ORDNANCE AND EXPLOSIVES ENGINEERING EVALUATION/COST ANALYSIS WORKPLAN

CONTRACT NO. DACA87-95-D-0018 TASK ORDER 0052

JUNE 8, 2000

Seneca Army Depot Activity

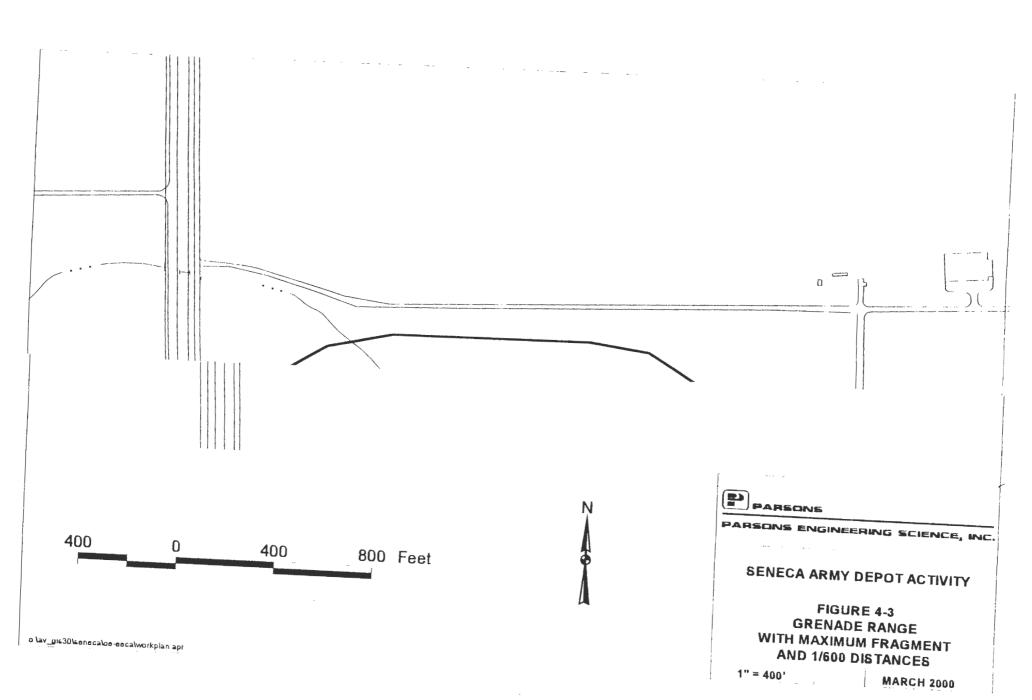
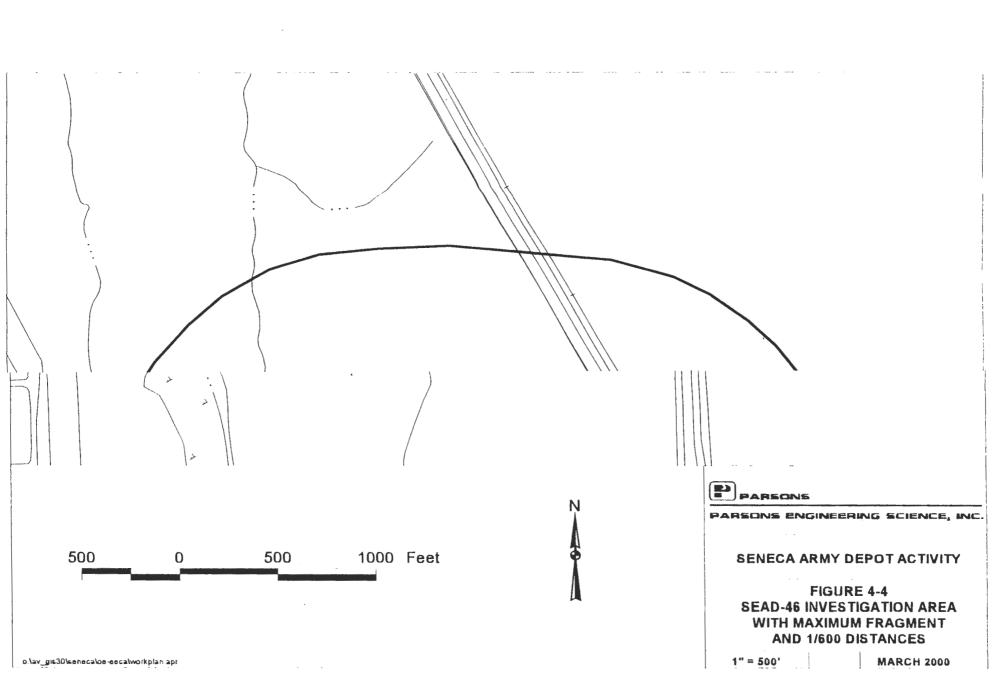
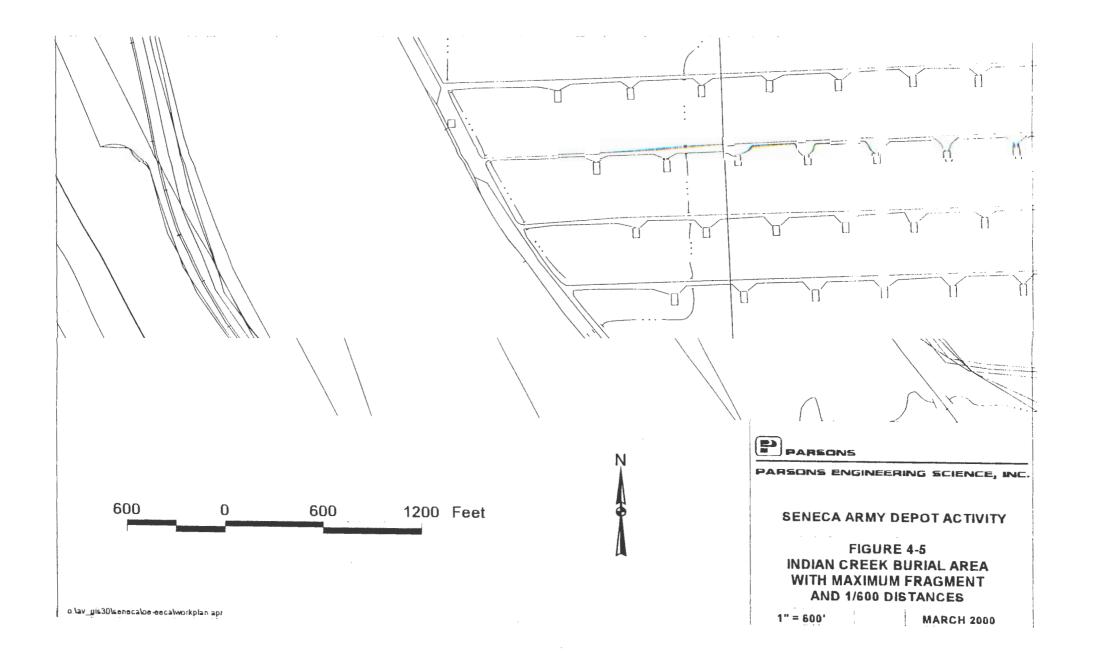
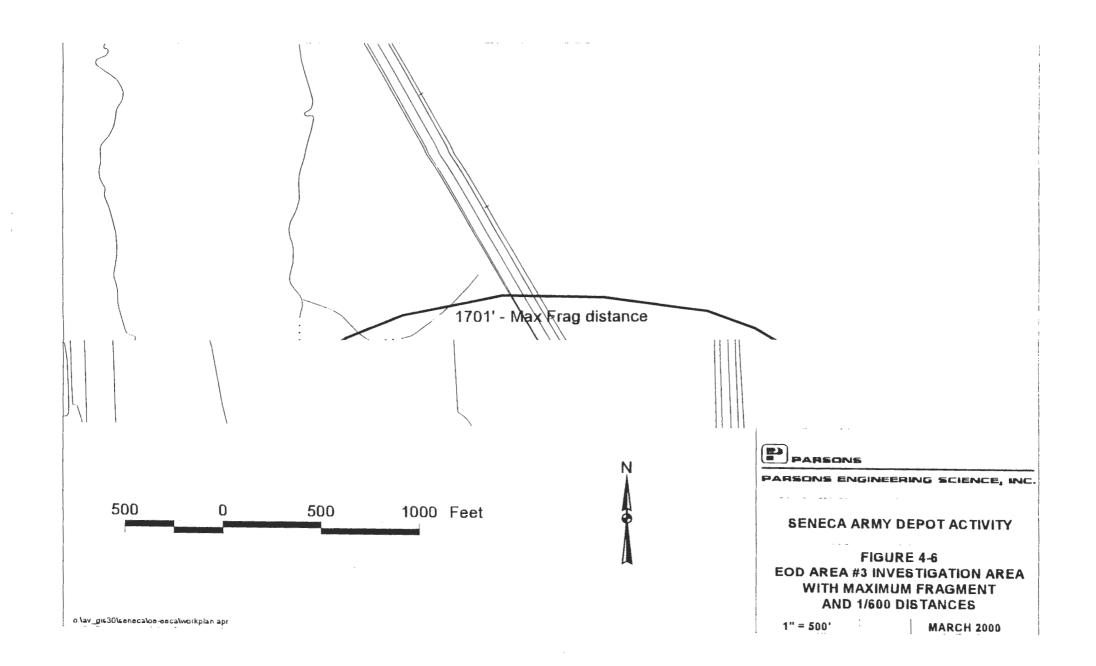
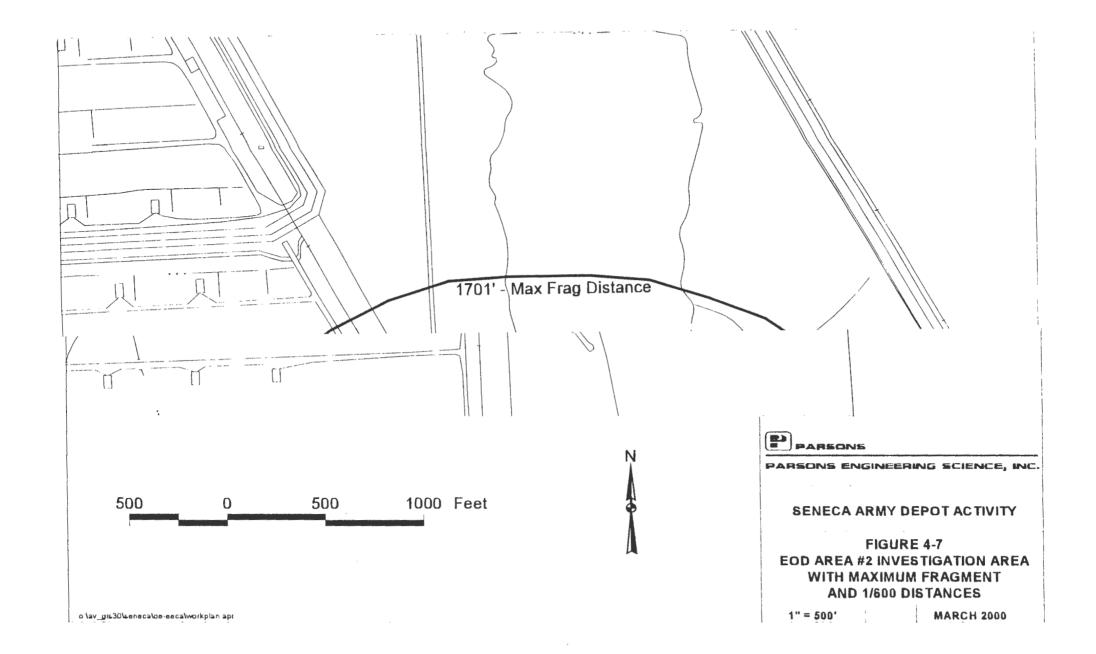
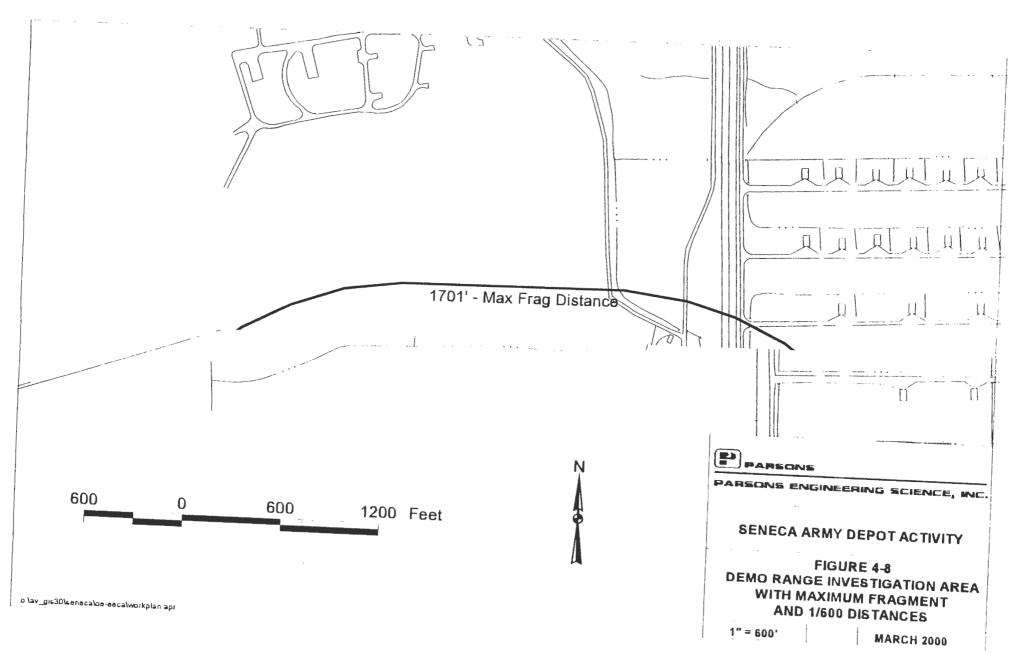
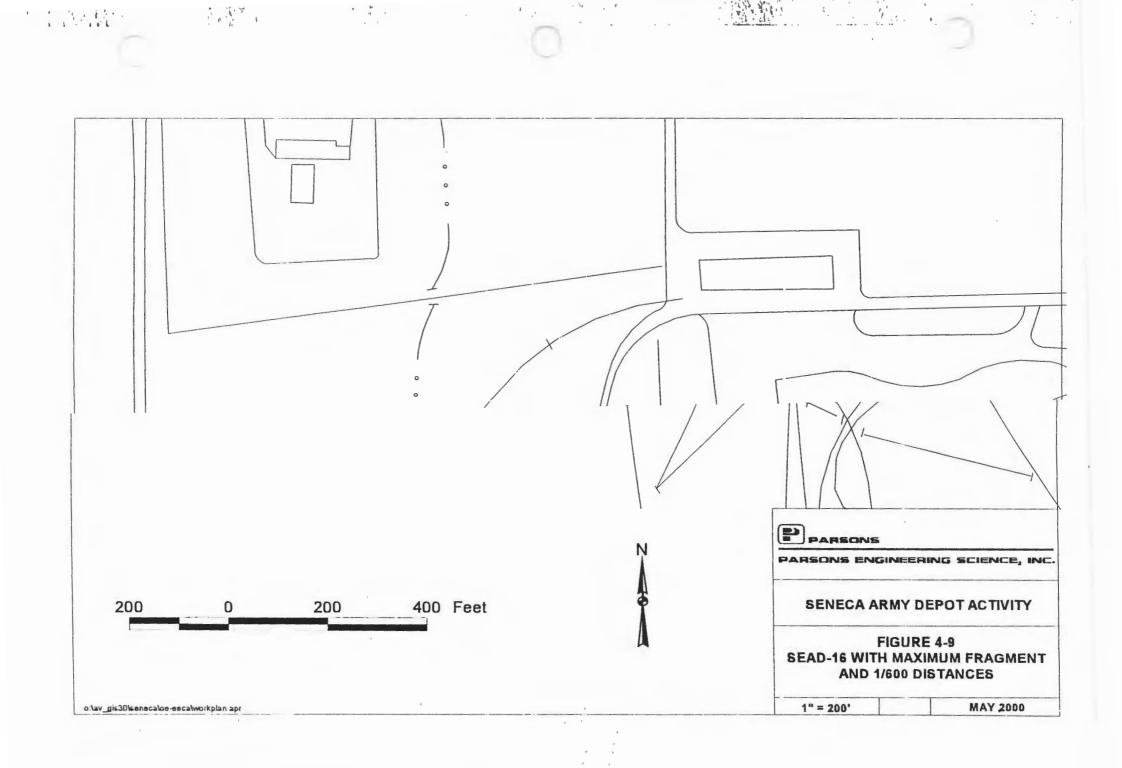
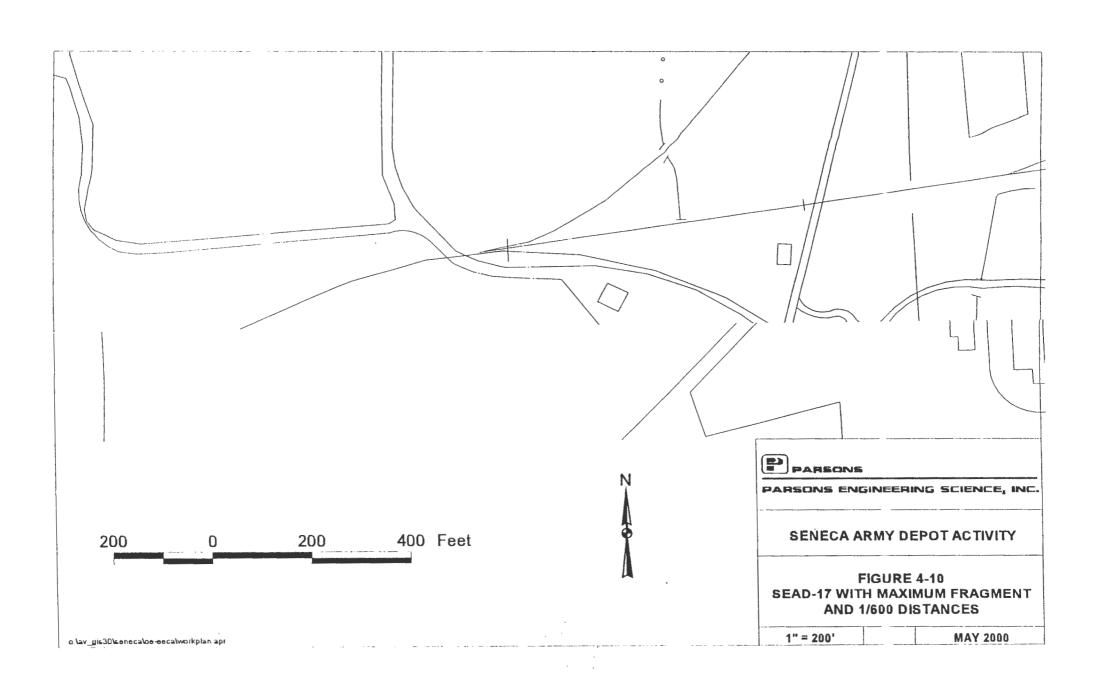
23.	Paragraph 4.3	1 st Sentence – Add Period after MSD.		Corrected.			
24.	General Figure 4-1 thru 4-8	Mark on each map, what the circles represent ( 1/600	Mark on each map, what the circles represent (e.g. xxxfeet (MSD), xxxfeet (1/600), 1/600				
		area boundary).

25.	Figure 4-1	Clarify - Table 4.4 shows the MSD for SEAD-4	5 as 2577 feet. This map shows it	See new figures. Note that the 1800 foot radius is			
		as 1800 feet. Correct to the right MSD.		the distance around the berms from detonations			
		Note: The map shows the MSD covering Hwy	96A and the HTRW construction s	ite there; if any UXO was kicked out to 1800 feet,			
		This will be a problem during intrusive activities	, as neither one of these area's wi	II the safe distance is another 2577 feet beyond that			
		be able to be shutdown. Need to address this is by ordnance personnel on Rte. 96 if possible;	now (e.g. request for 1/600', chang	for blow in place. We will attempt to use the 1/600 distance for intrusives and stop the road for actual			
				planned detonations; if this is not appropriate, we			
				will coordinate with local authorities.			
<b>26</b> .	Figure 4-2	Clarify - Table 4.4 shows the MSD for SEAD-5	7 as 1233 feet. This map shows

as 1800 feet. Correct to the right MSD.		Corrected. See figure 4-2.			
27.	Paragraph 5.3	Change Twele to Twelve.		Corrected.			
		ACTION CODES W - WITHD A - ACCEPTED/CONCUR N - NON-C D - ACTION DEFERRED VE - VE PC

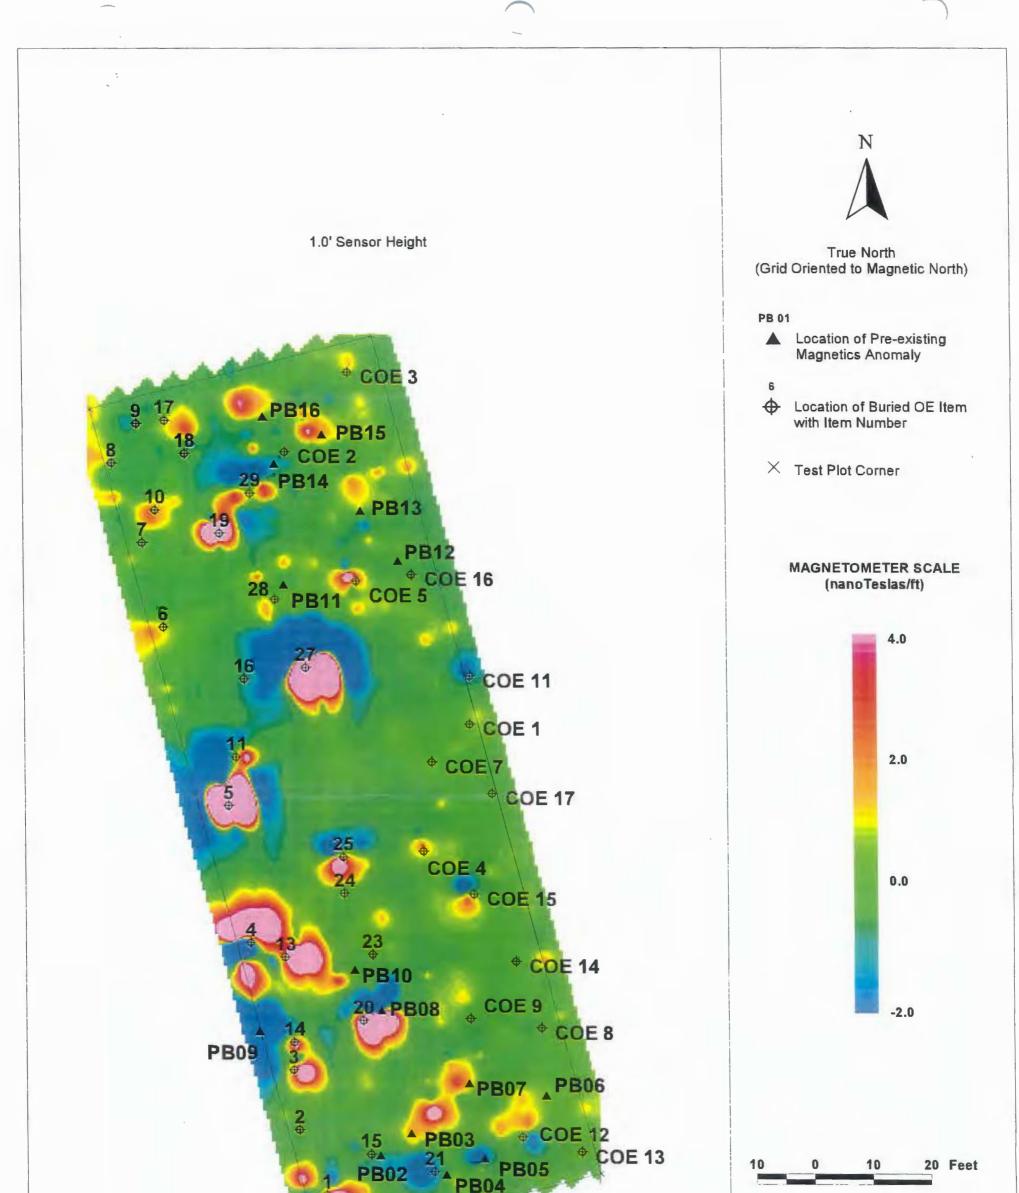
ITEM       DRAWING NO. OR REFERENCE       COMMENT       ACTION         8.       Figure 17       I am curious as to what the unselected anomalies are between PB 06 and PB 05: 15 and       After the switch to gradient rather	t
TTEM       OR REFERENCE       CONNELLYT       ACTION         8.       Figure 17       I am curious as to what the unselected anomalies are between PB 06 and PB 05: 15 and       After the switch to gradient rather	
	1
max) produced additional pre-bur These additional pre-bur of the anomalies in question. The U2 on the original map (now betw is believed to be a surface or near Parsons side of the grid, as it is pr sensor height maps (figs. 17 and 1 anomaly is included in the last part is included in the last part is inc	f fig. 5 (baseline mag rial anomaly picks. alies accounted for two e third, between 15 and ween PB03 and PB07), r surface anomaly on the resent only on the 1.0' 18). A discussion of the
